RFB-2022-20
PRINCETOWN SHERIFF'S SUBSTATION RENOVATIONS & NEW CONSTRUCTION
C2 DESIGN GROUP

ADDENDUM #2

Issued Date: 03/04/2022

3 Building Section Through Shed Roof
SCALE: 1/4" = 1'-0"

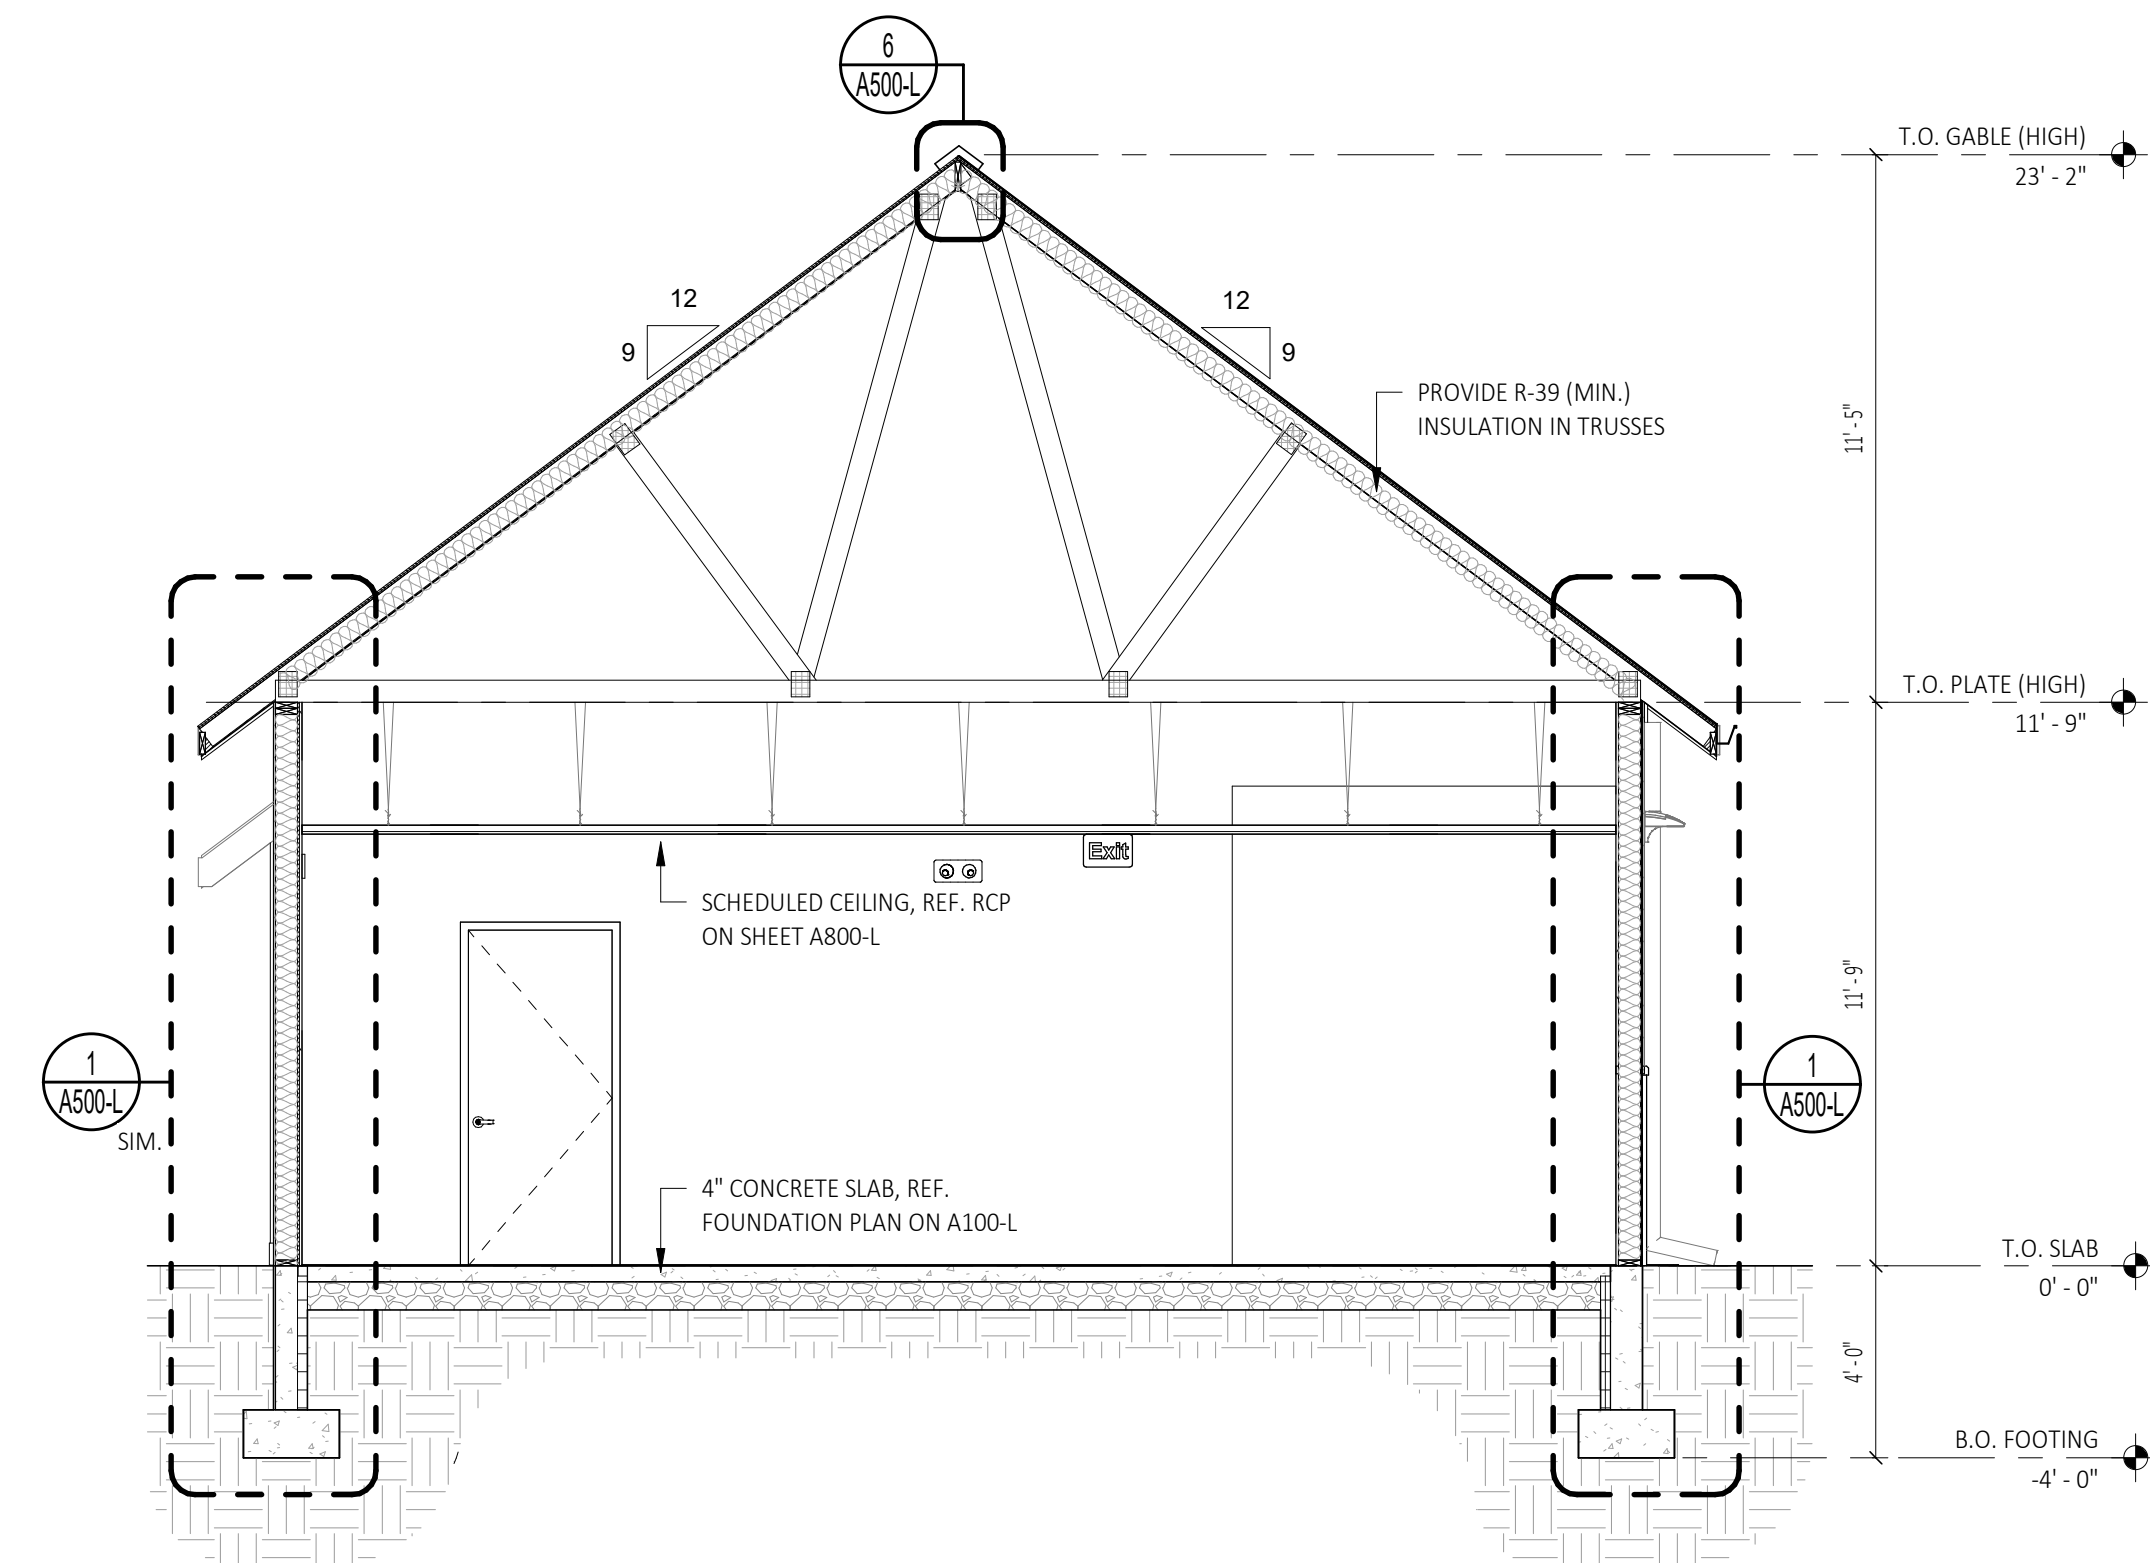
Confirm "shed" roof at Locker Addition connector is stick built with 2x10 rafters. Plan drawings indicate trusses, section shows 2x6 rafters.

Shed roof at Locker Addition connector is to be trusses at 24" O.C. Provide 2x10 rafter overbuild to connect to existing roof as indicated on A103-L. The roof framing plan on A103-L and section 3/A300-L has been revised to clarify.

5 Typical Roof Edge Detail
 A500-L SCALE: 1 1/2" = 1'-0"

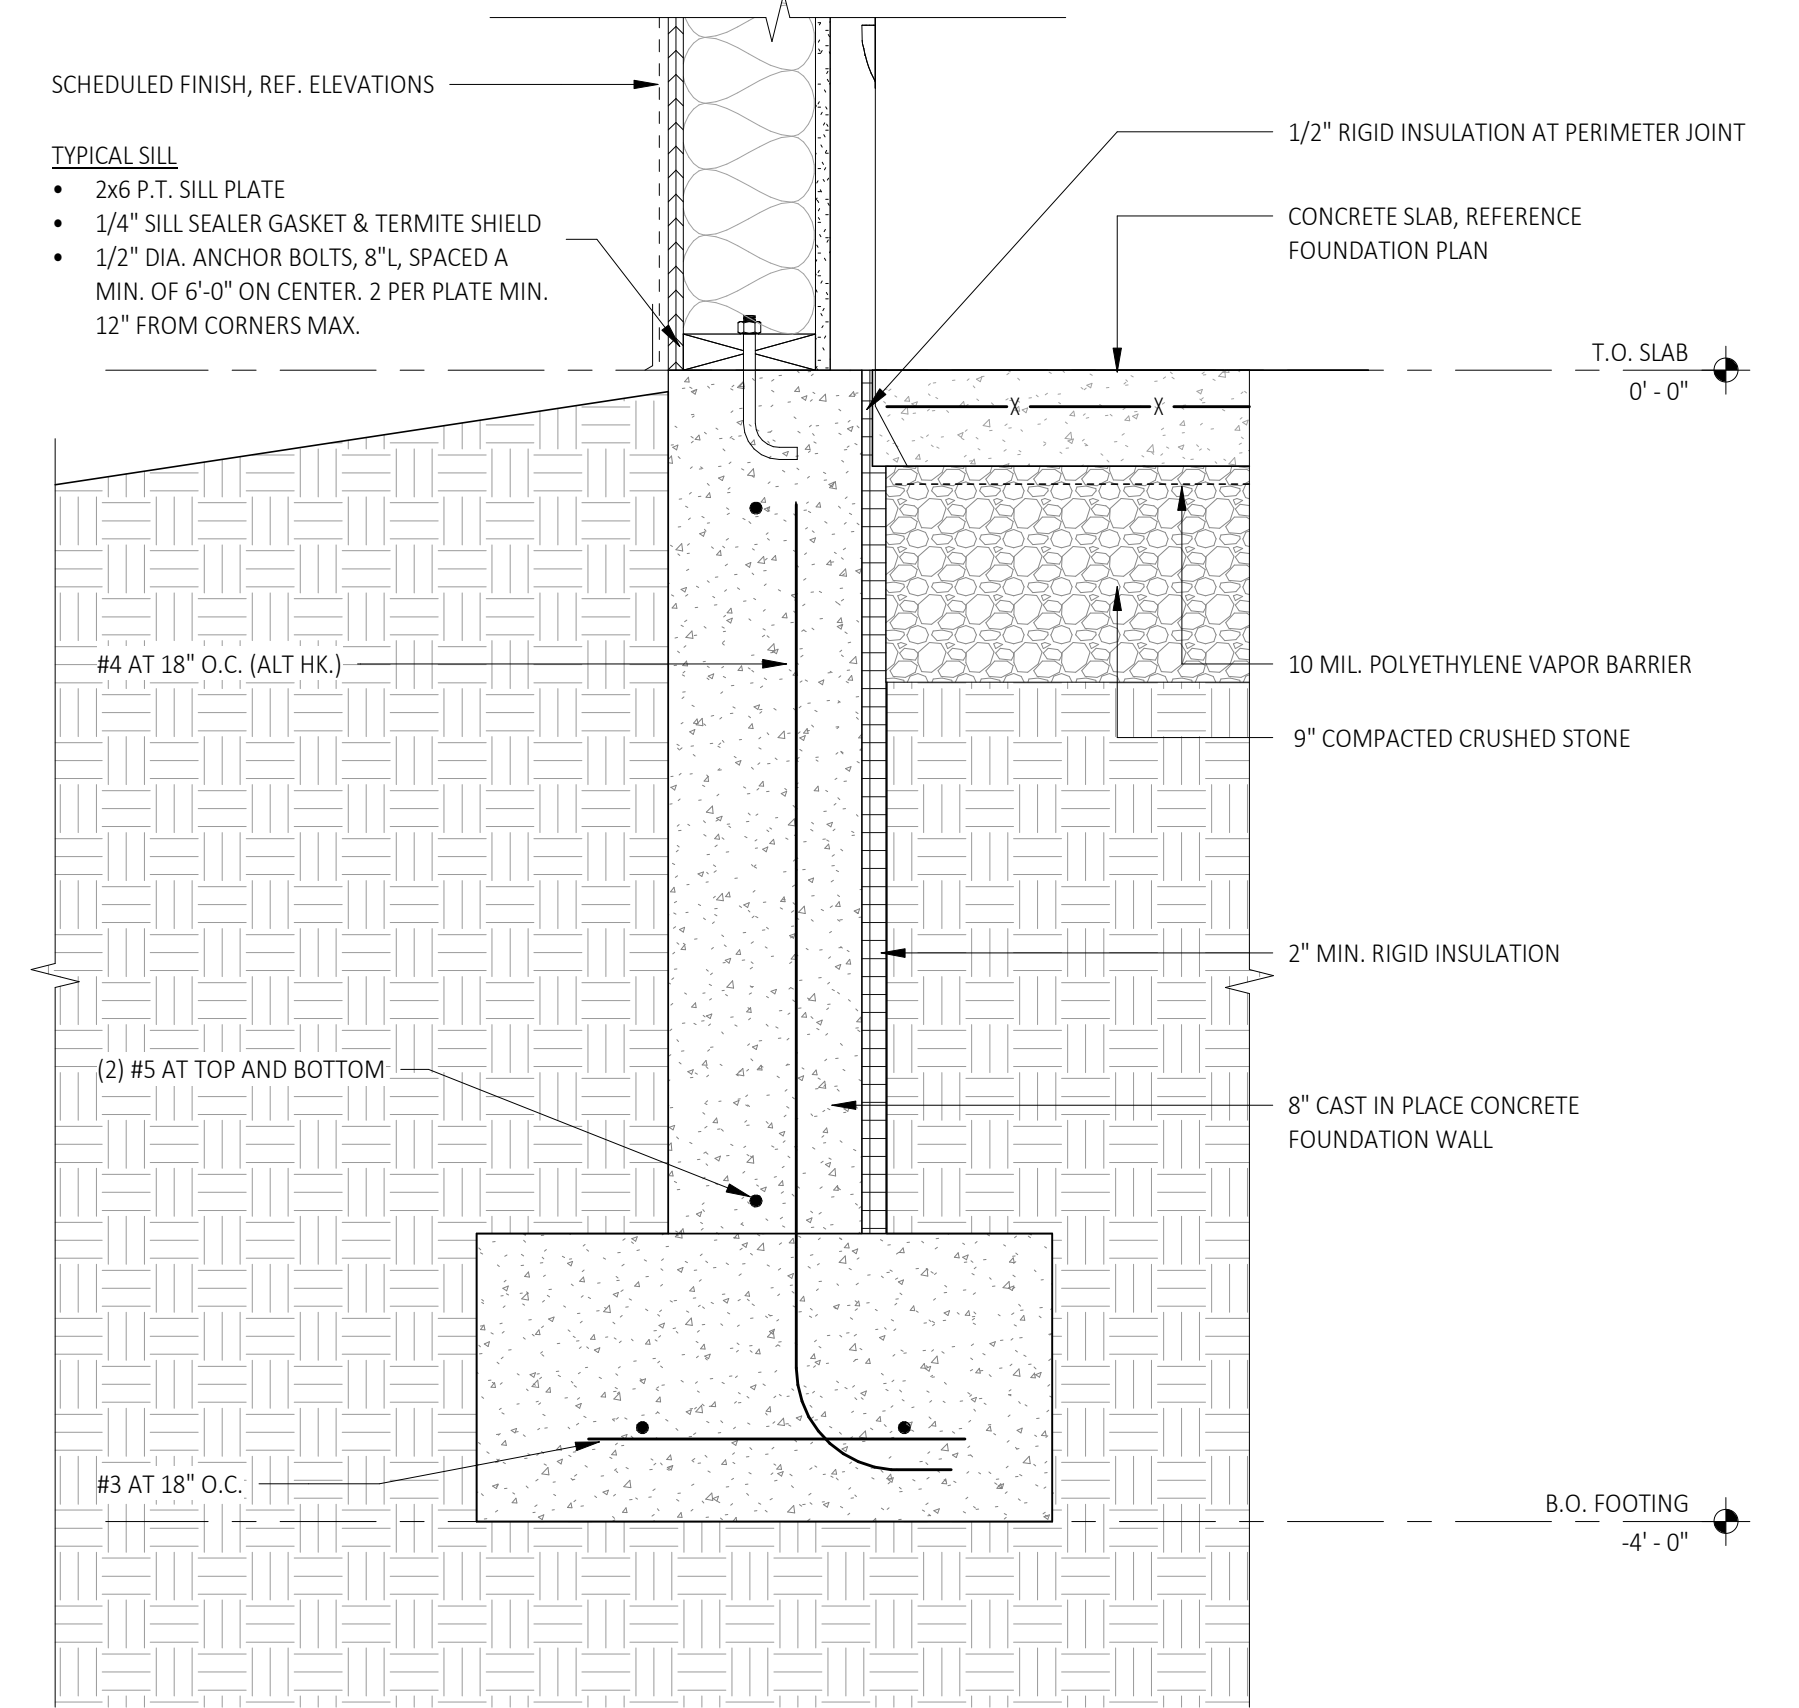
Confirm you want 7/16" ZIP sheathing for roof sheathing on trusses at 24" O.C. per details on A500-L

Provide 5/8" ZIP sheathing for roof. Detail 5/A500-L has been revised to show 5/8" ZIP sheathing.

Window Head, Jamb, Sill Details

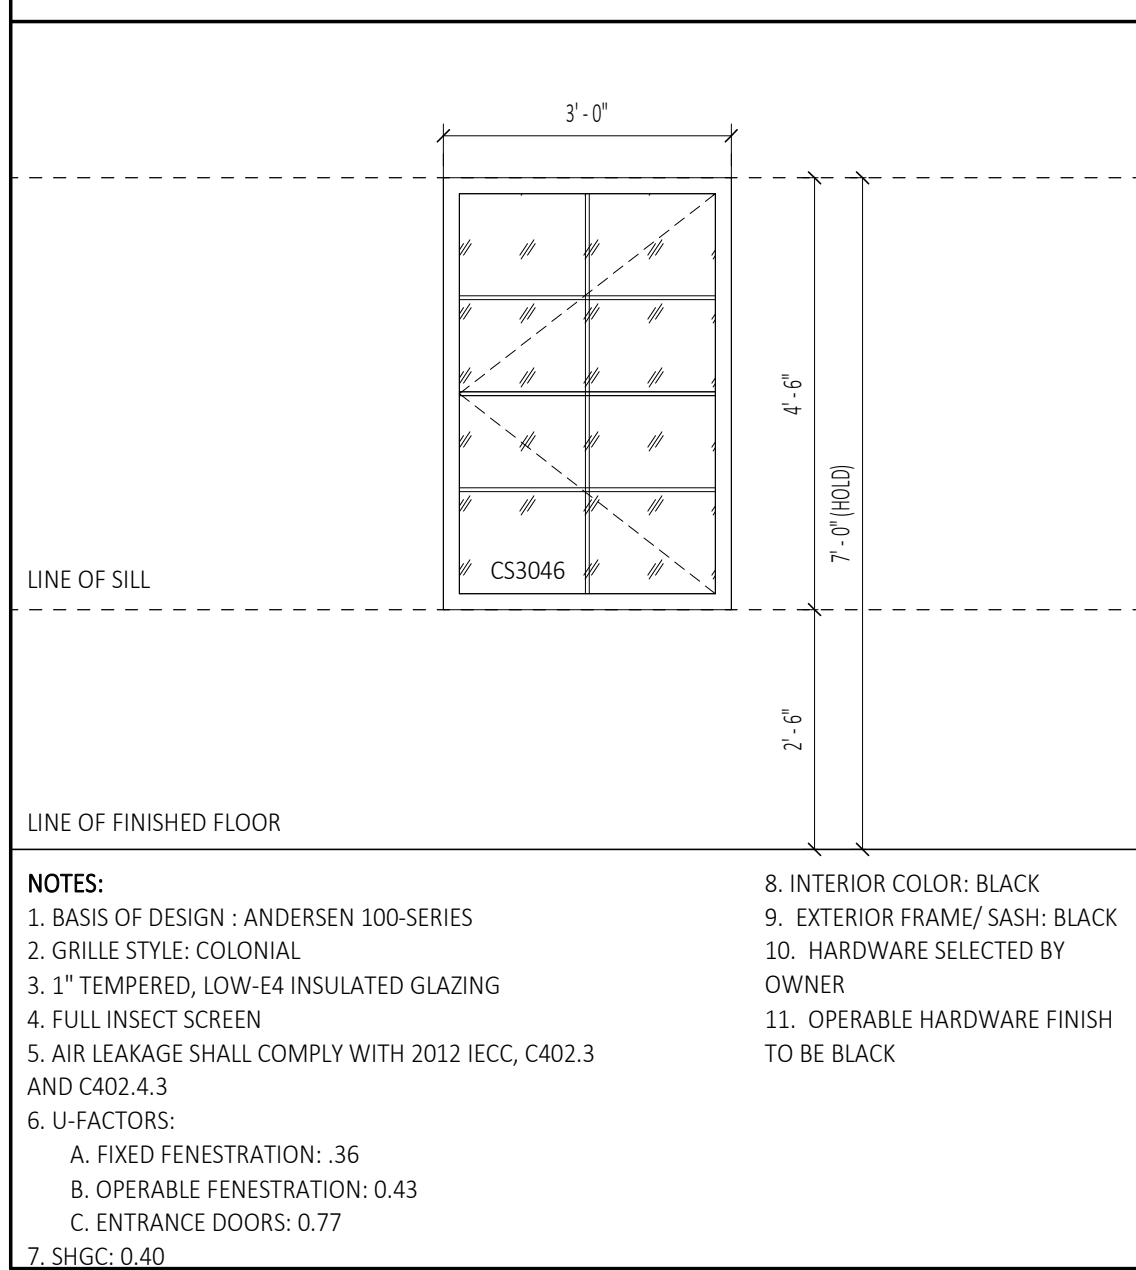
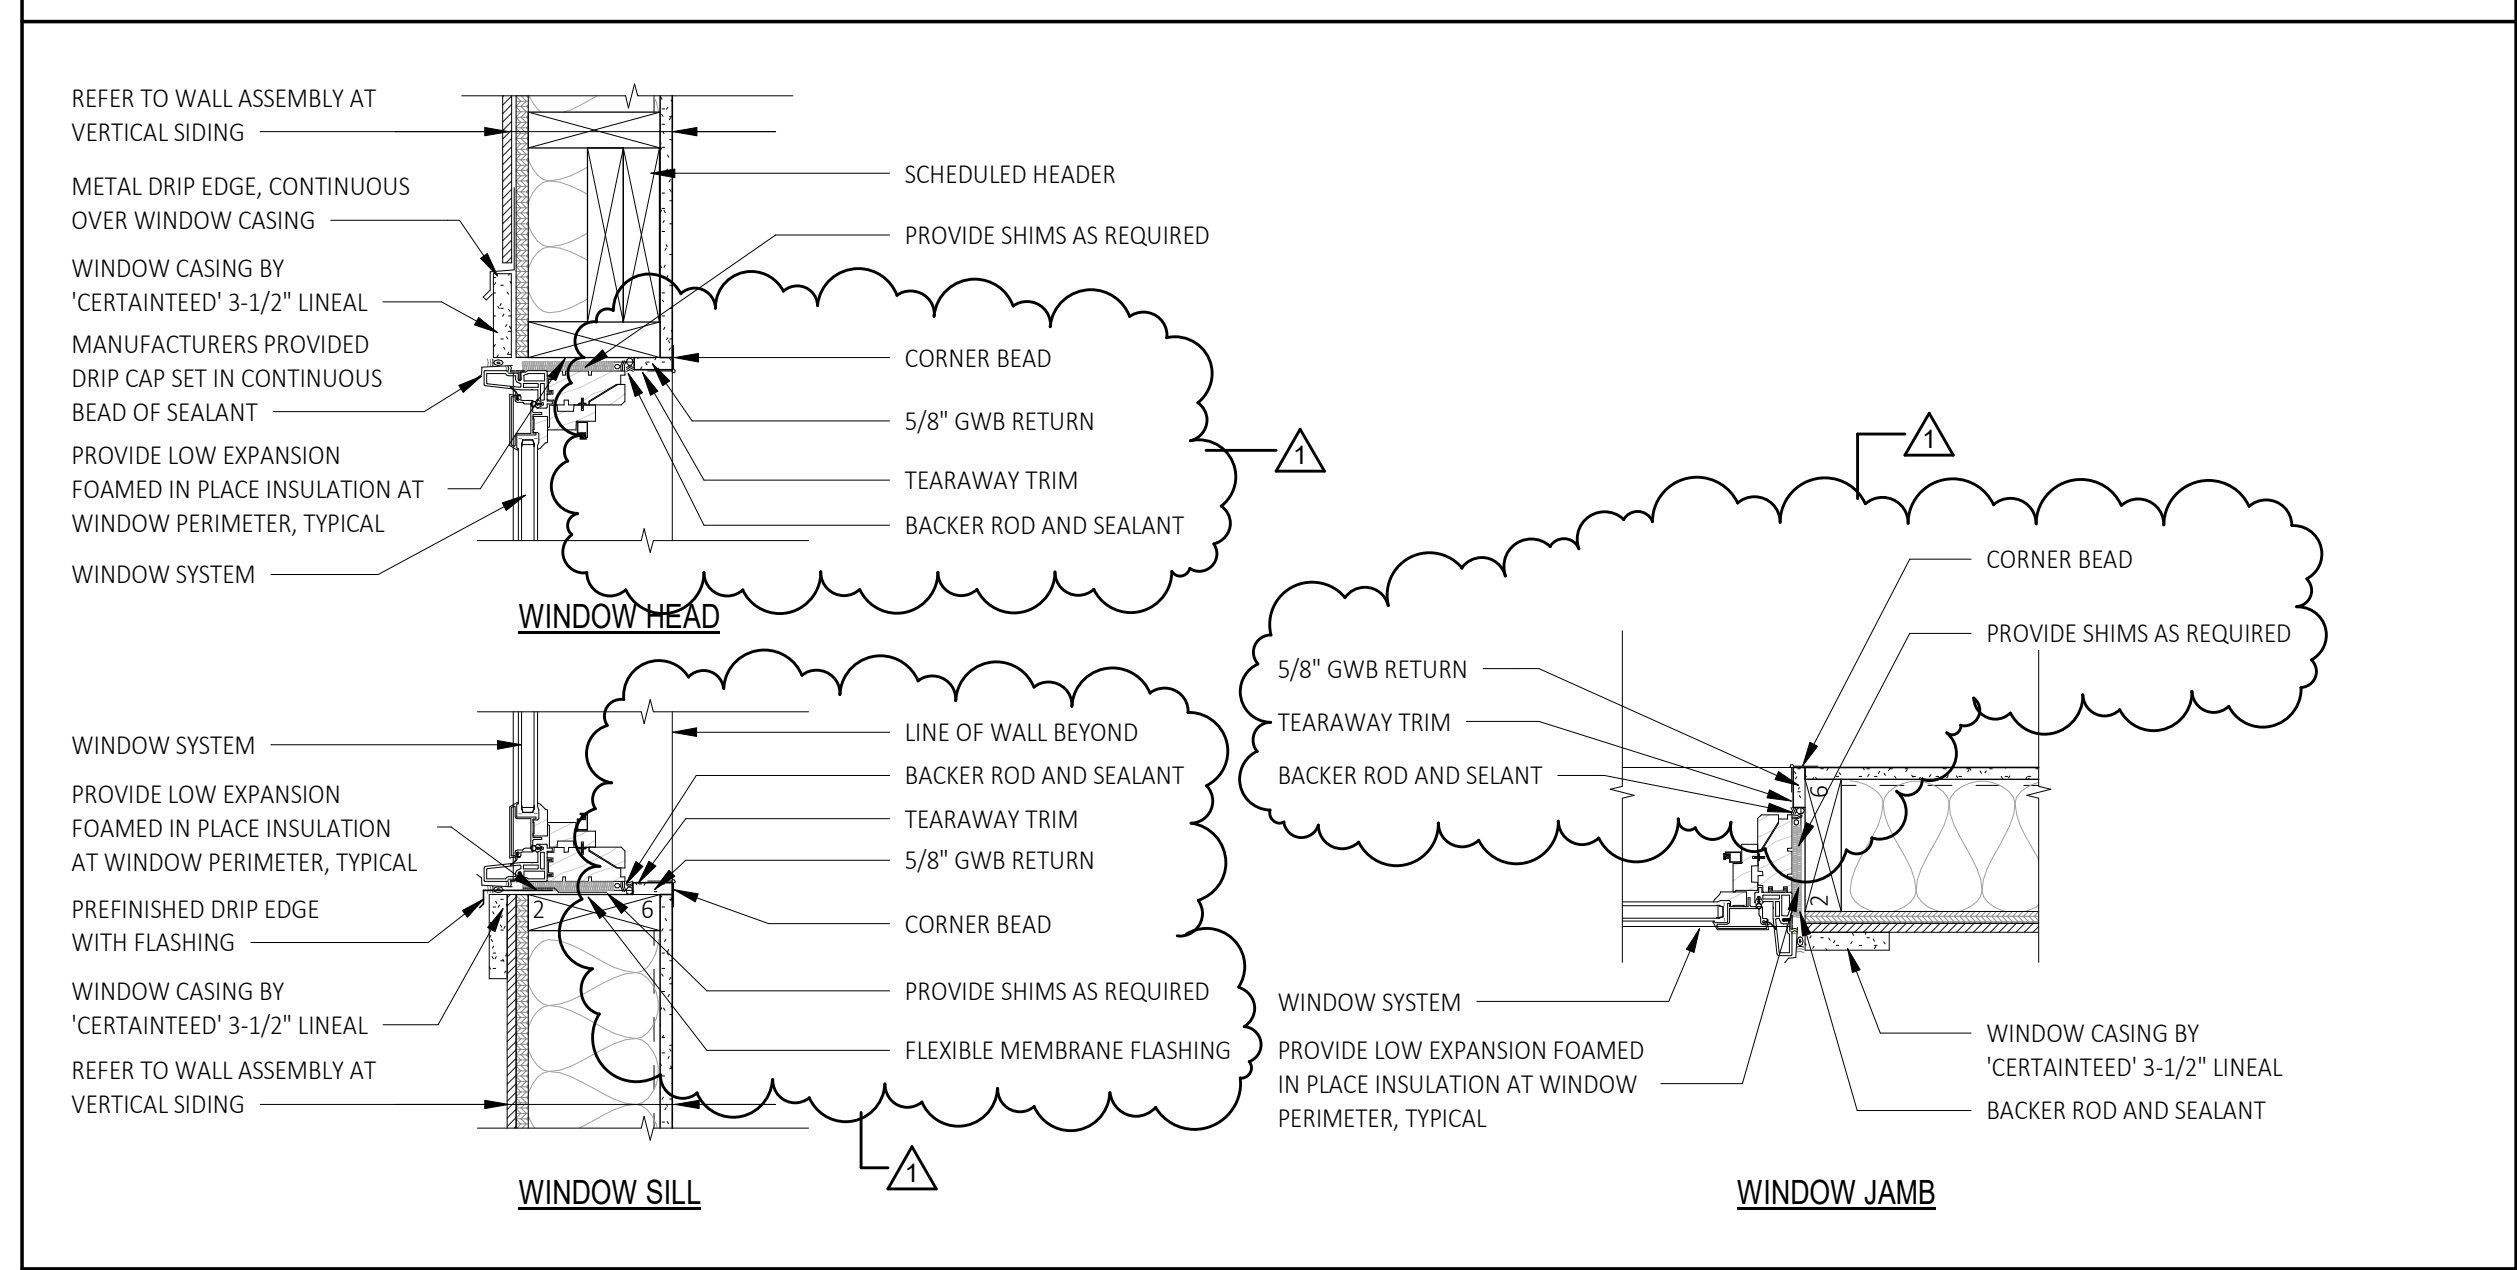
Please clarify interior Azek window trim. Window head calls for 1"x4" Azek trim. Window sill calls for 1"x4" Azek trim and window jamb calls for 1/4"x4" Azek trim. Is this correct? Is the intent to square cut the trim at the head and sill and have the 1/4" thick leg material run vertical in between with square cuts? Or is the trim to be picture framed and mitered at the corners. If so 1/4" material for the legs won't work.

Interior window trim to be 5/8" GWB returns for all heads / jambs and sills. Provide corner bead at perimeter and tear-away trim at window with backer rod and sealant. The window details on A900-L and A900-G have been revised.
